CITY OF LOS ANGELES
INTER-DEPARTMENTAL CORRESPONDENCE

4311 W. Sunset Bl
DOT Case No. CEN20-50708

Subject: **UPDATED TRANSPORTATION ASSESSMENT FOR THE PROPOSED MIXED-USE PROJECT LOCATED AT 4311 WEST SUNSET BOULEVARD**

Attachment 1
4311 W. Sunset Bl

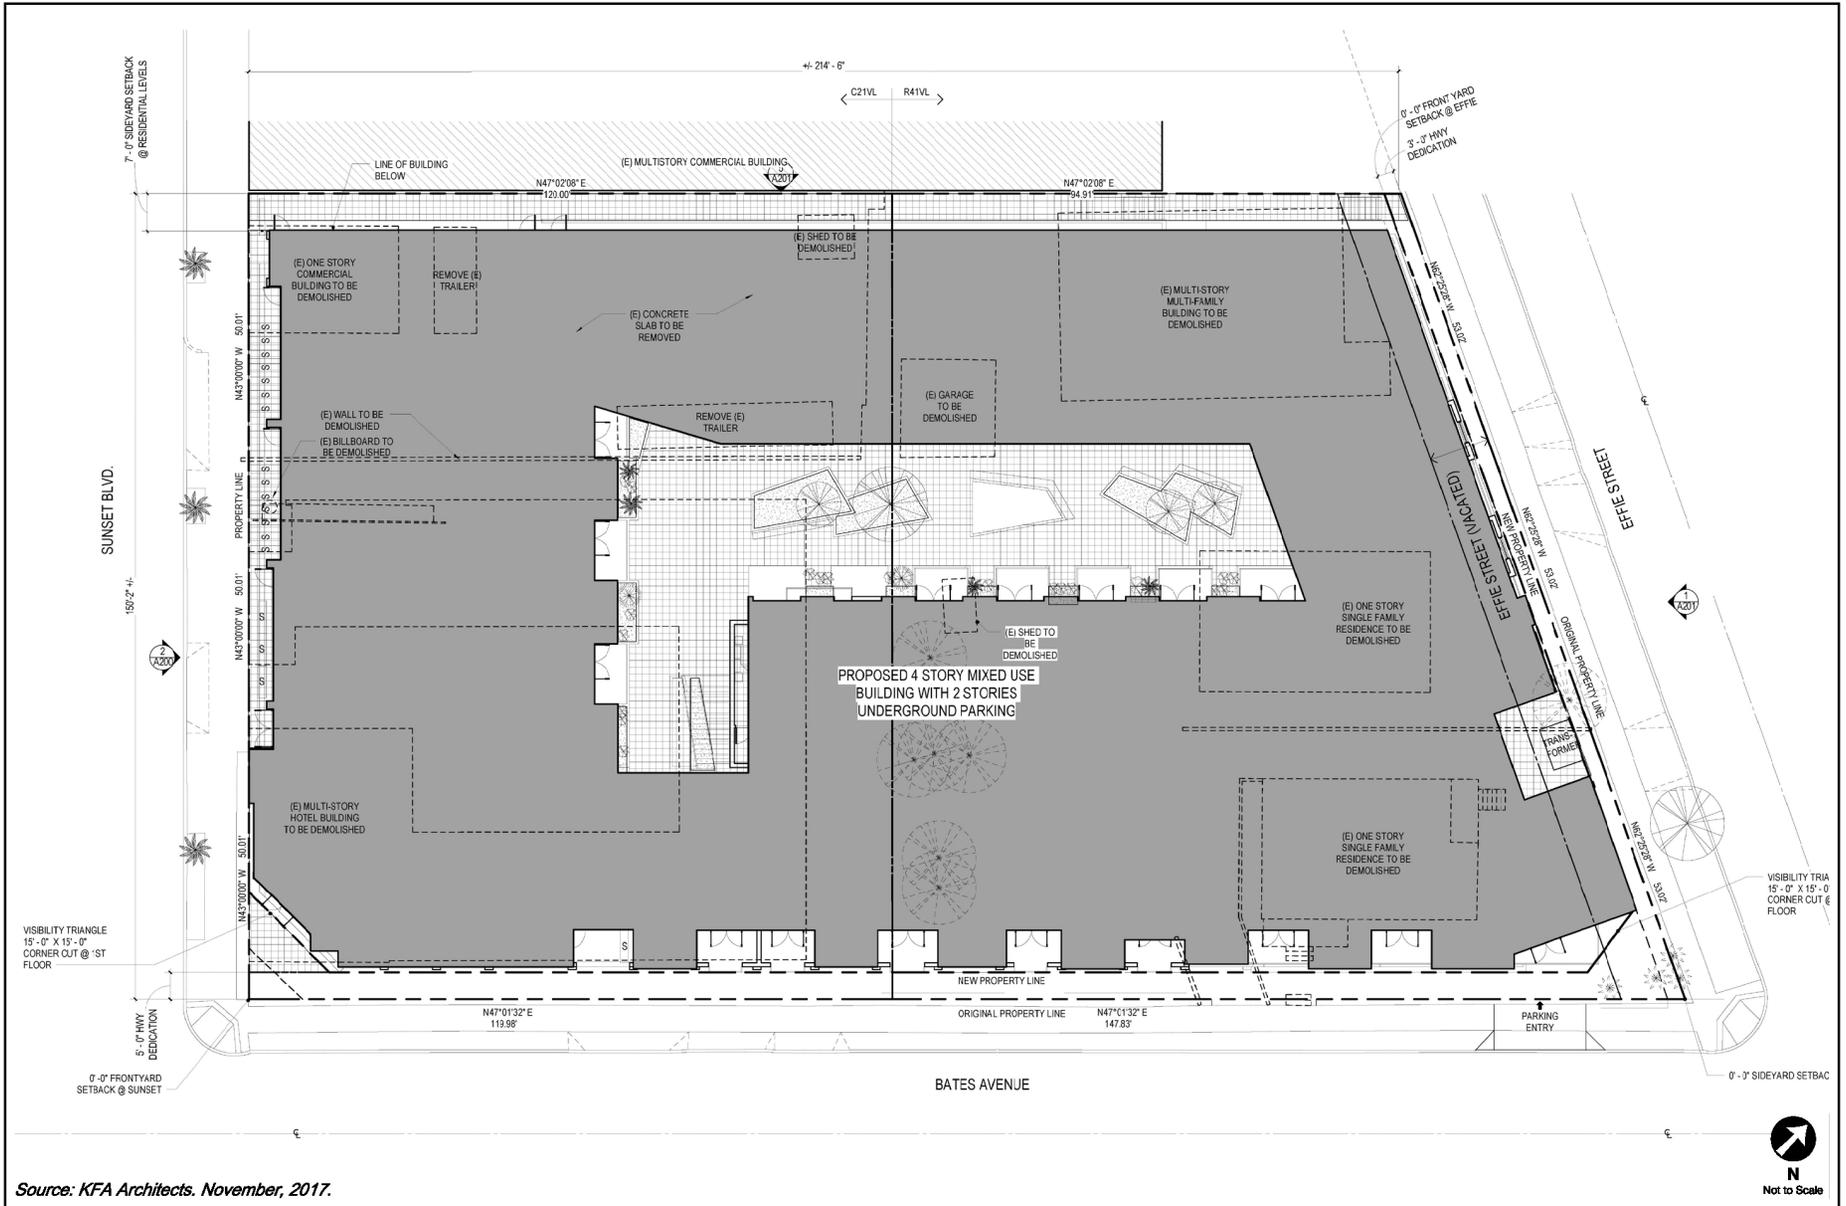
The conceptual site plans for the development (see Attachment 1) are acceptable to DOT. However, the review of this study does not constitute approval of the driveway dimensions, access and circulation schemes. Those require separate review and approval and should be coordinated as soon as possible with DOT's Citywide Planning Coordination Section (201 N. Figueroa Street, 5th Floor, Room 550, at 213-482-7024). In order to minimize and prevent last minute building design changes, the applicant should contact DOT for driveway width and internal circulation requirements so that such traffic flow considerations are designed and incorporated early into the building and parking layout plans to avoid any unnecessary time delays and potential costs associated with late design changes. All driveways should be Case 2 driveways and 30 feet and 16 feet wide for two-way and one-way operations, respectively, and any

security gates should be a minimum 20 feet from the property line. All delivery truck loading and unloading should take place on site with no vehicles having to back into the project via any of the project driveways.
